City of TIFFIN

DATE:	August 27, 2026
AGENDA ITEM:	Approval of Change Order #3 – Tricon Construction Group – Water Treatment Facility Upgrade
ACTION:	Motion

CHANGE ORDER NO.: 3

Owner:	City of Tiffin	Owner's Project No.:	
Engineer:	MSA Professional Services	Engineer's Project No.:	13603021
Contractor:	Tricon Construction Group	Contractor's Project No.:	25-012-IA
Project:	Tiffin WTF Upgrade		
Contract Name:	13603021 – Tiffin WTF Upgrade		
Date Issued:	August 19, 2026	Effective Date of Change Order:	September 1, 2026

PROJECT NO. 13603016
SHEET 10A102

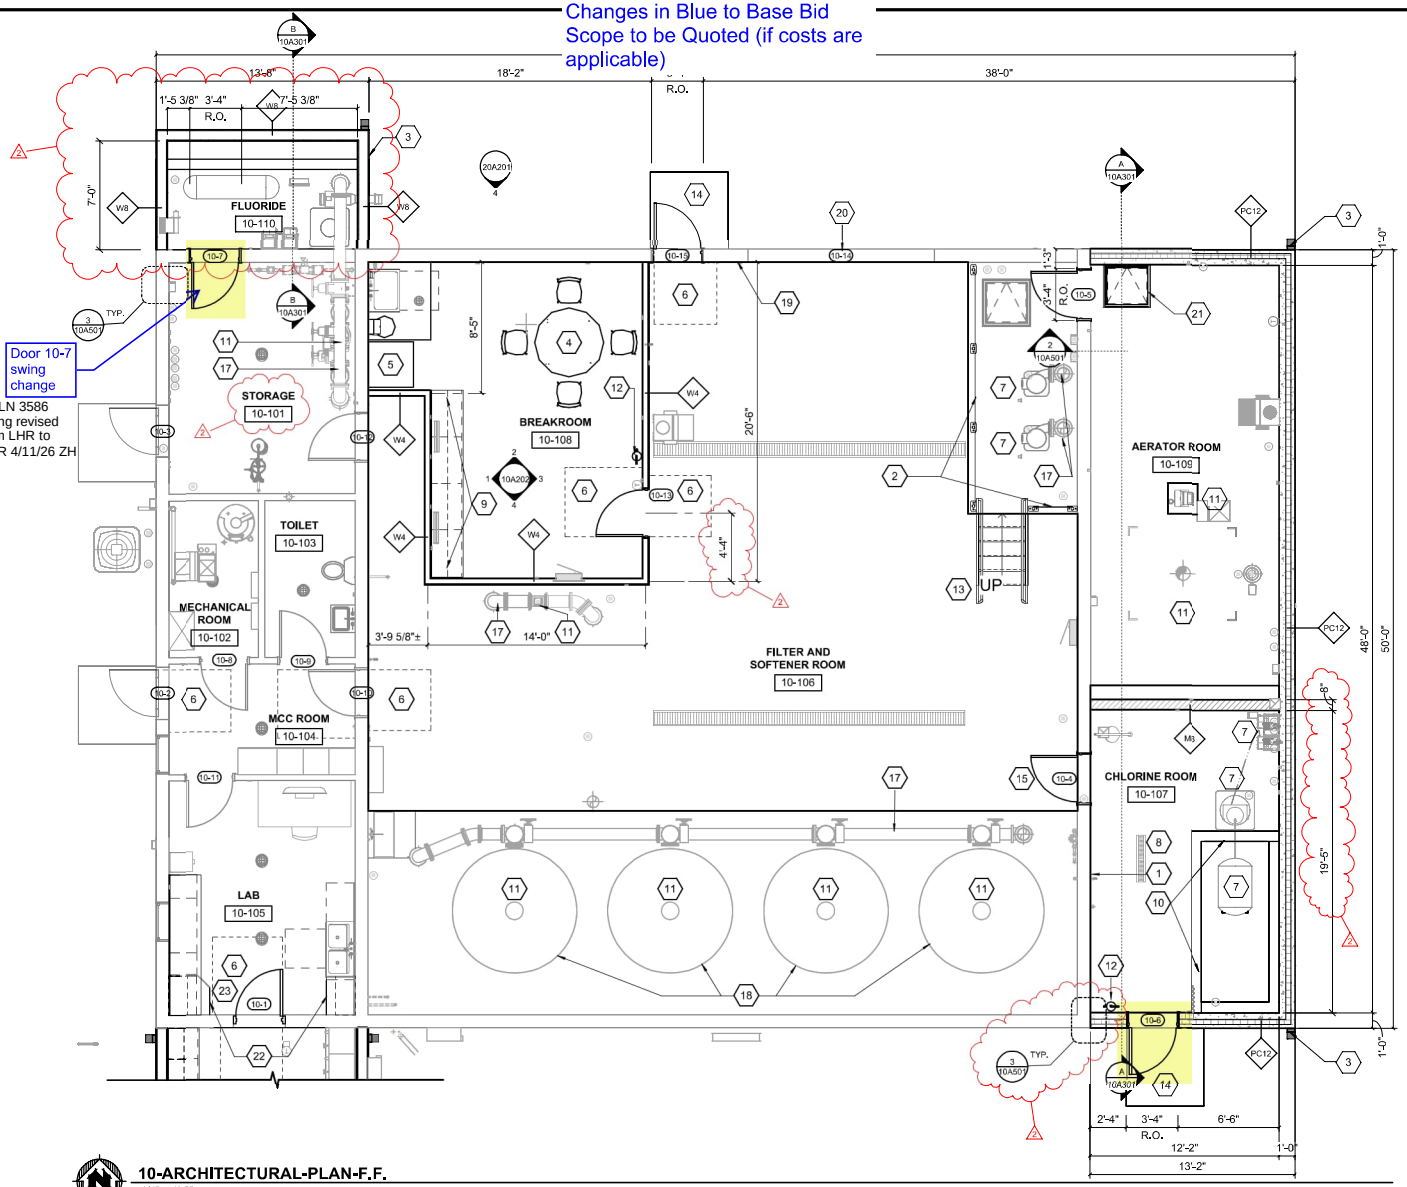
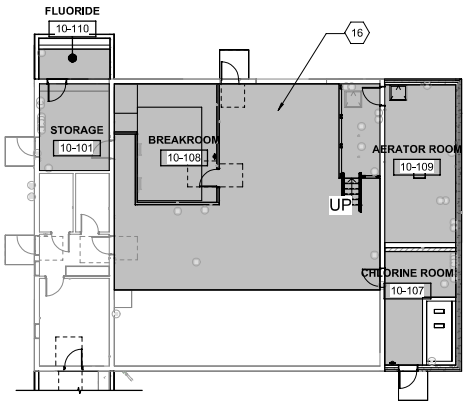
Please include doors 10-6 and 10-7 as well in the FRP scope for CO#2. All doors that we would possibly sub the SS hardware in CO#3 needs to have an FRP door/ frame in CO#2, with the exception of 10-4 which is only changing hardware.

1. REMOVE EXISTING STEEL FACE AND REPLACE WITH GYPSUM BOARD & FRP SURFACE LAMINATED TO PLYWOOD.
2. ALUMINUM GUARD RAIL - SEE DETAIL 8/99A504
3. DOWNSPOUT LOCATION, CONNECT INTO STORM DRAIN - SEE YARD PIPING PLAN

PROJECT NO. 13603016
SHEET 20P102

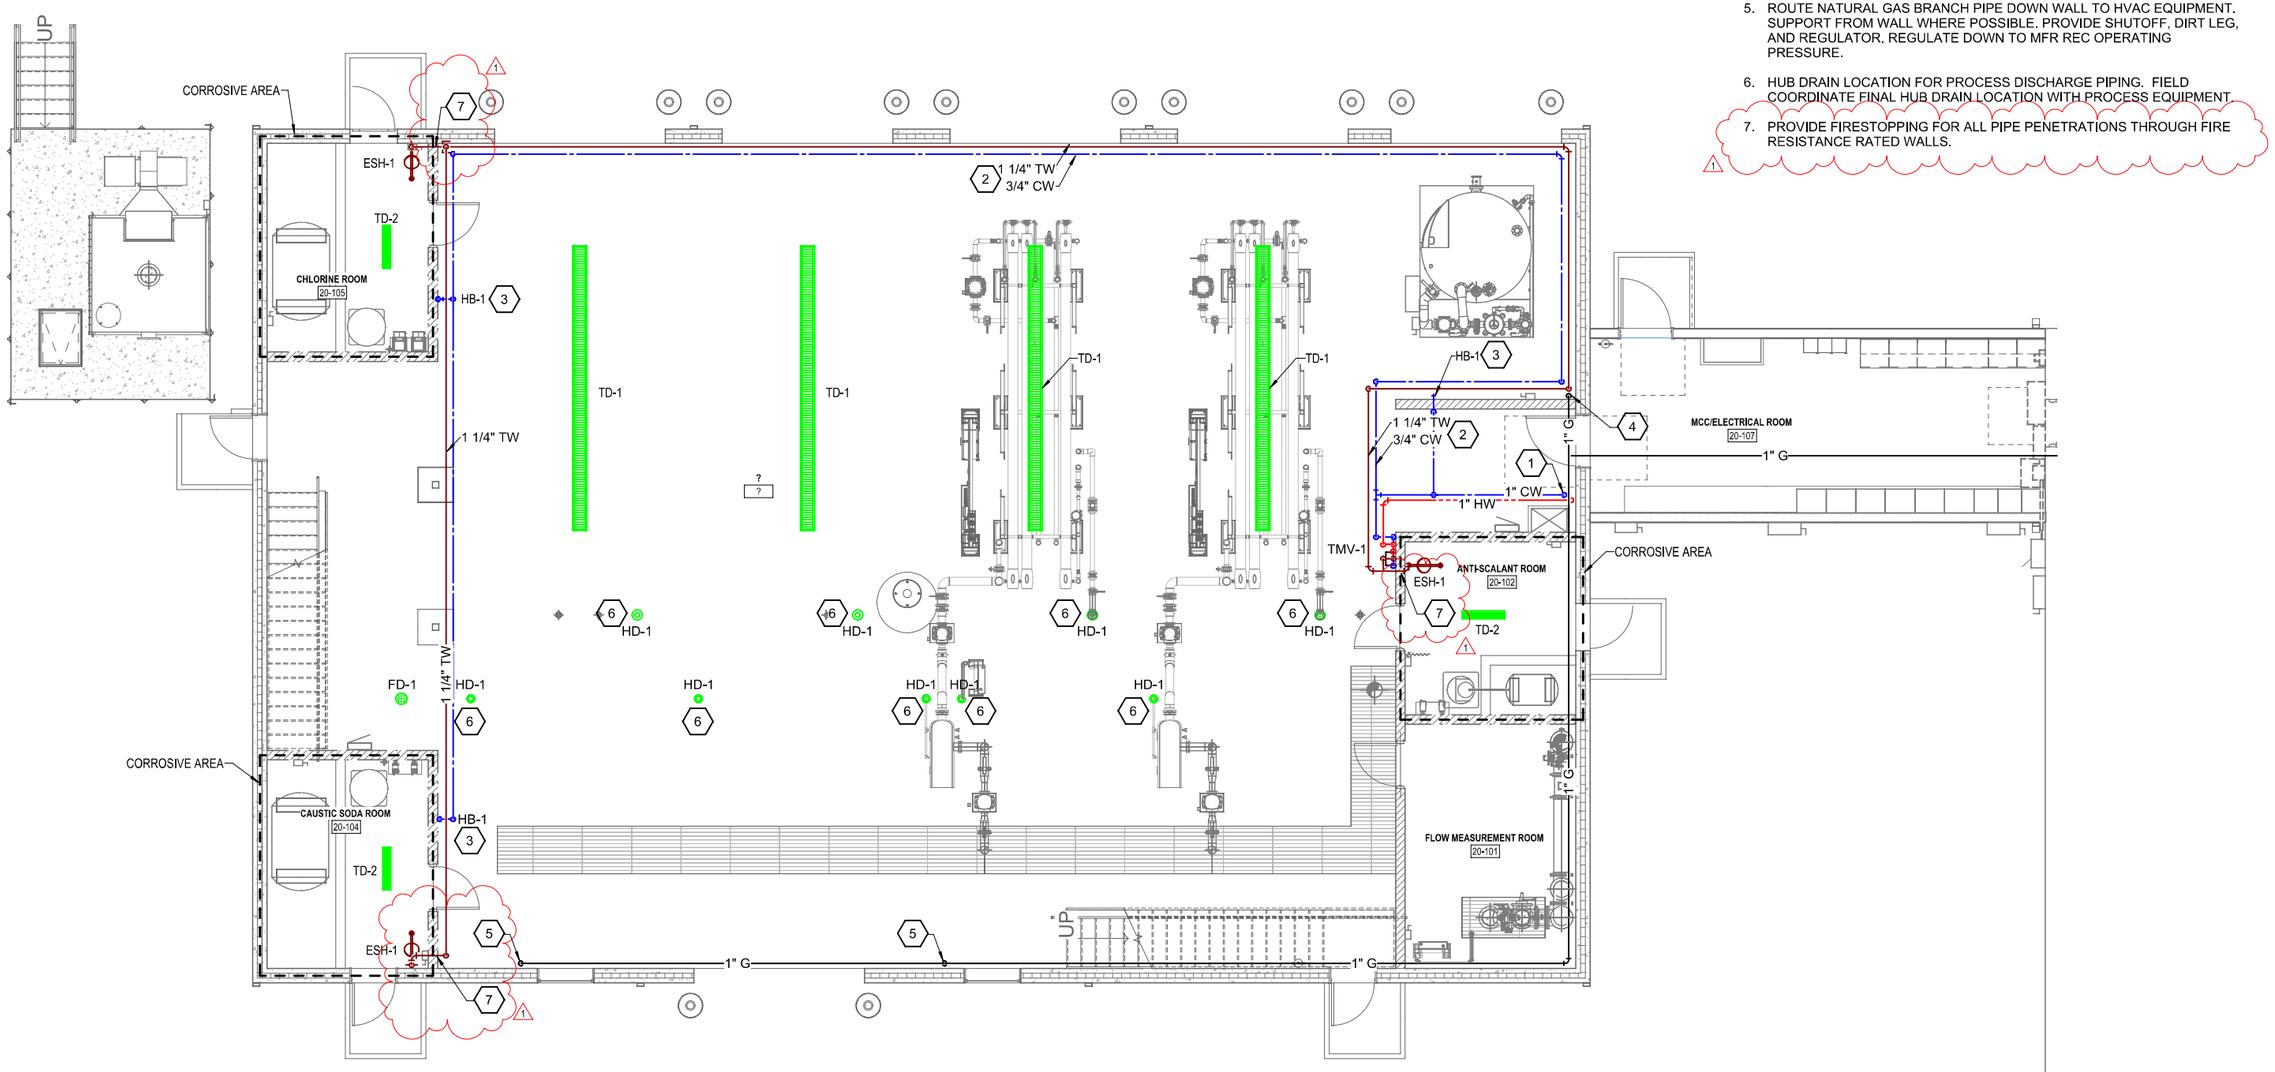
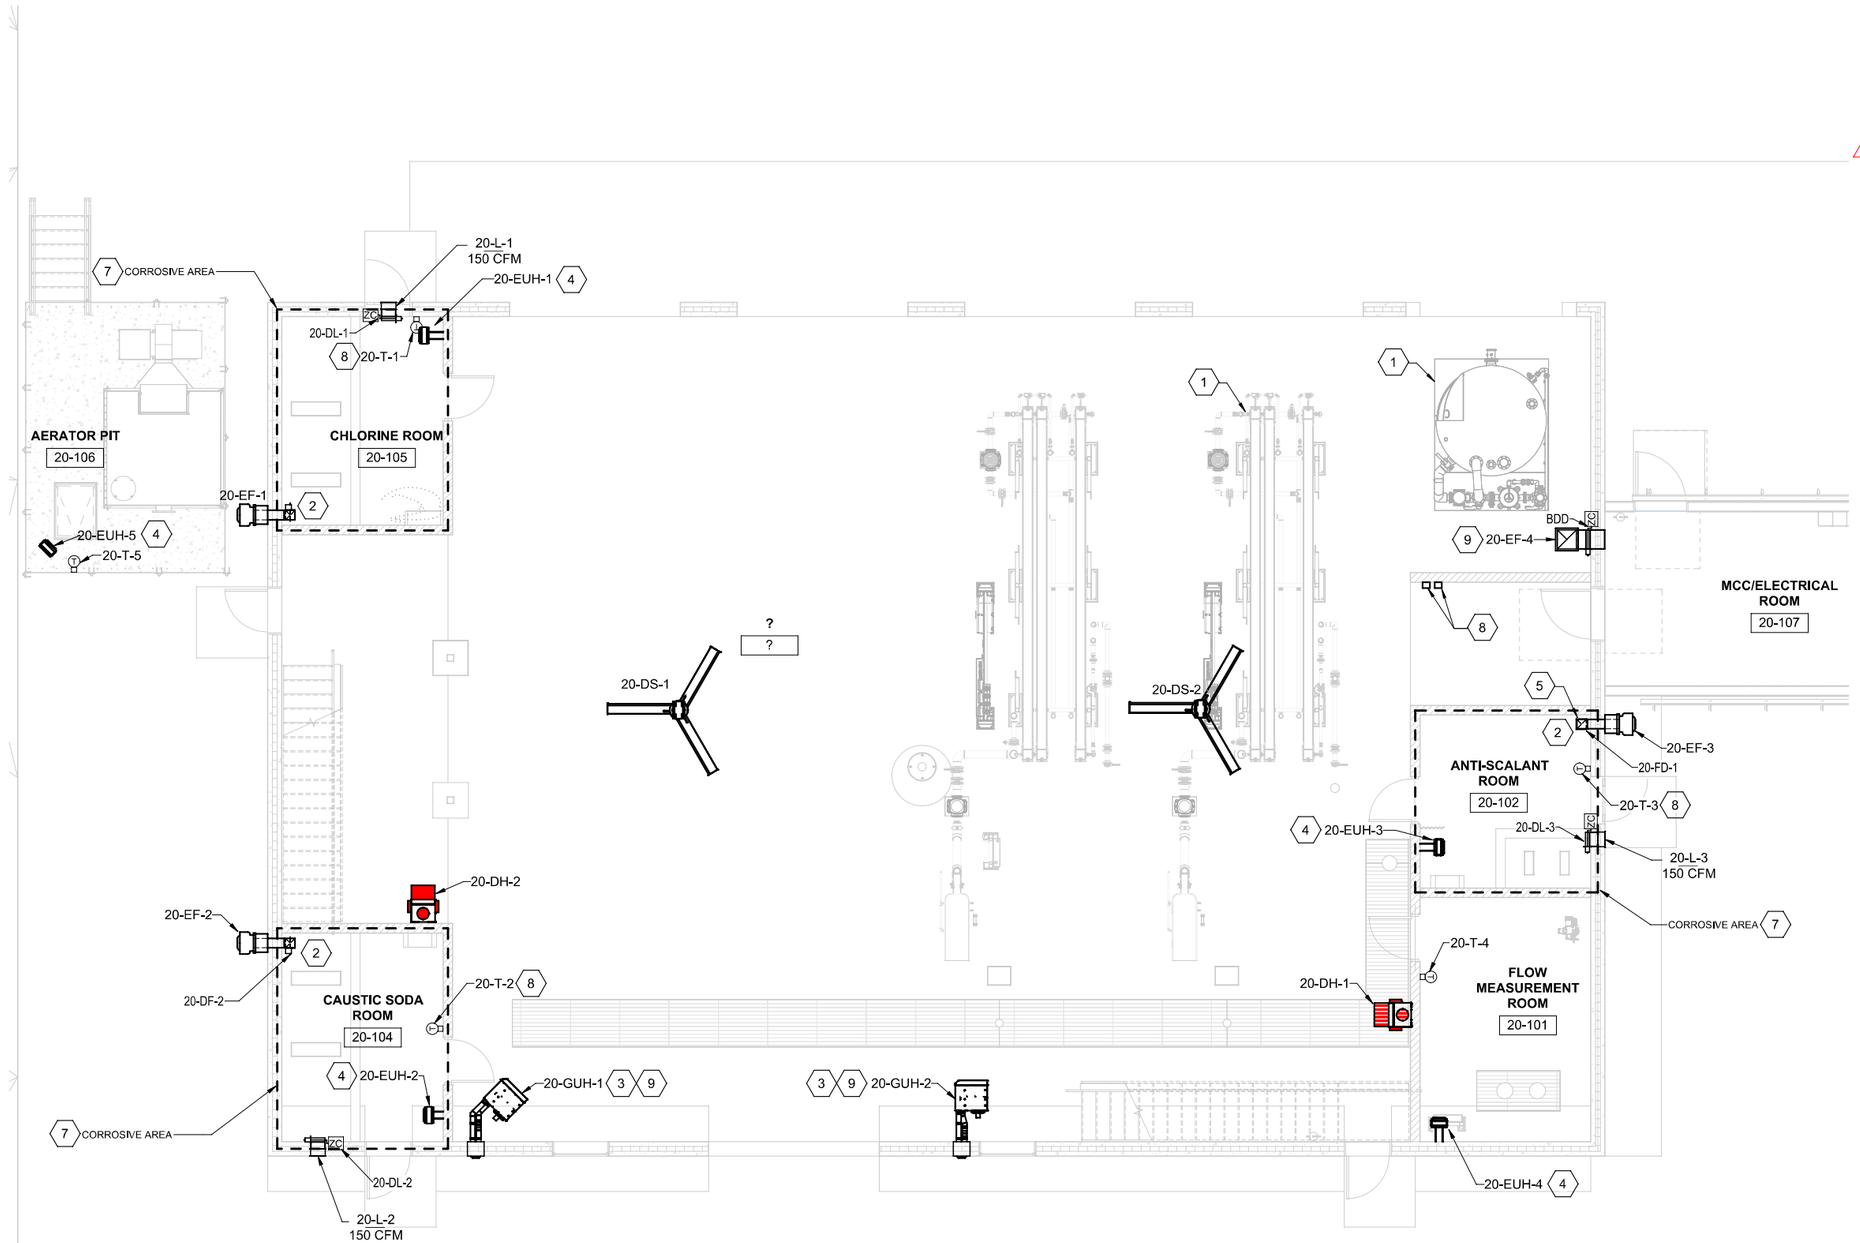
Project Name: TIFFIN WWT
Date: 11/24/2025
Project Number:
Prime Contractor Direct Costs TRICON
Description of Change: FIRESTOPPING THROUGH FIRE RATED WALLS & FIRE DAMPER.

1. NEW HOT AND COLD WATER PIPING UP THROUGH FLOOR. ROUTE UP INSIDE WALL AND HIGH AS POSSIBLE. SUPPORT FROM WALL.
2. PIPING SHOWN IN APPROXIMATE LOCATION. OFFSET PIPING AS NECESSARY TO NEW FIXTURES. SUPPORT PIPING FROM WALL WHERE POSSIBLE.
3. ROUTE 3/4" DOWN TO CONNECTION ON HOSE BIBB. PROVIDE LINE SIZED SHUTOFF VALVE IN VERTICAL.
4. ROUTE PIPING UP UP WALL TO CEILING. SUPPORT VERTICAL PIPING FROM WALL.
5. ROUTE NATURAL GAS BRANCH PIPE DOWN WALL TO HVAC EQUIPMENT. SUPPORT FROM WALL WHERE POSSIBLE. PROVIDE SHUTOFF, DIRT LEG, AND REGULATOR. REGULATE DOWN TO MFR REC OPERATING PRESSURE.
6. HUB DRAIN LOCATION FOR PROCESS DISCHARGE PIPING. FIELD COORDINATE FINAL HUB DRAIN LOCATION WITH PROCESS EQUIPMENT.
7. PROVIDE FIRESTOPPING FOR ALL PIPE PENETRATIONS THROUGH FIRE RESISTANCE RATED WALLS.

PROJECT NO. 13603016
SHEET 10A100

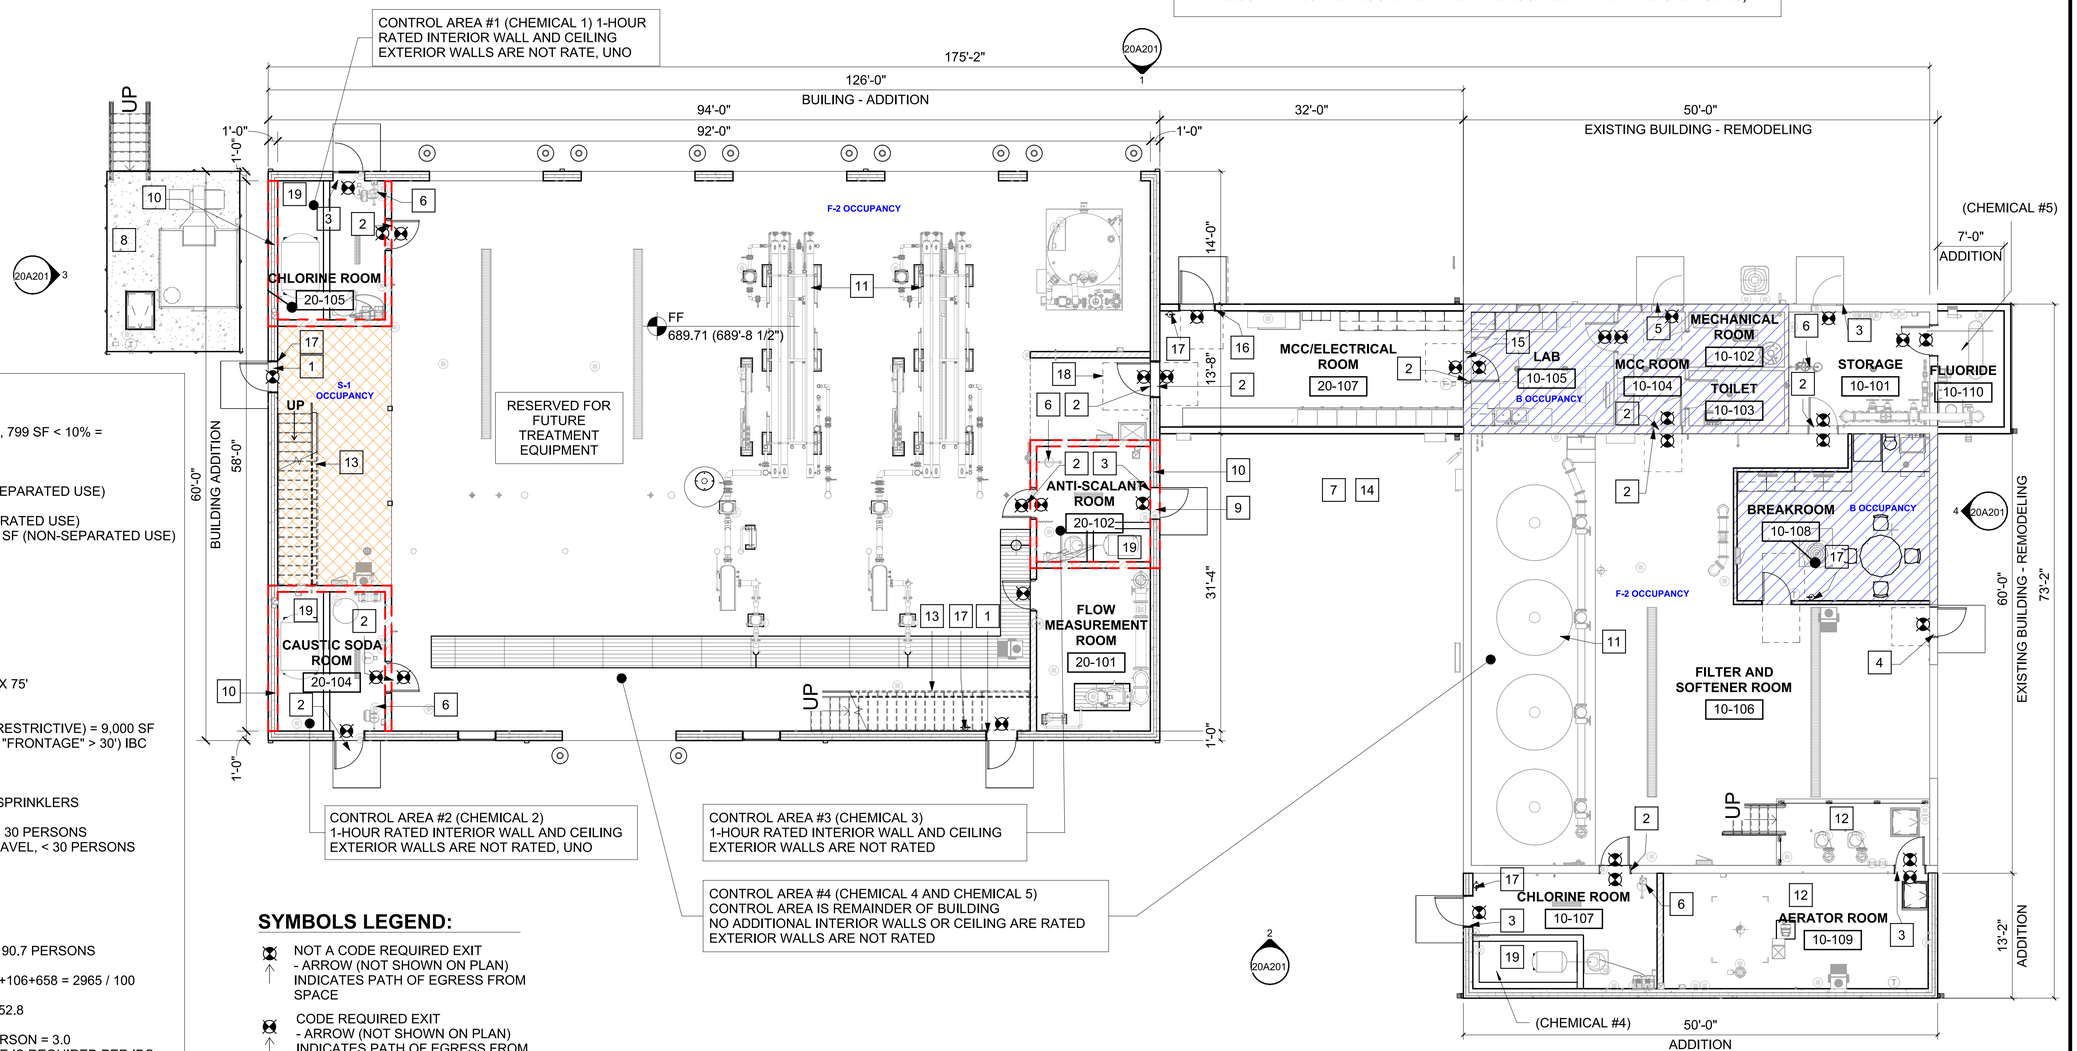
2) Provide a Life Safety Plan for this project including area Uses and Occupancy Classifications, Occupant Loads, Egress Travel distances, Common Path of Travel distances where applicable, Accessible routes, Exit locations and sizing, Fire Extinguisher and fire protection elements, etc. <7/21/25 NS>

Life safety plans have been included for your review. (MSA)
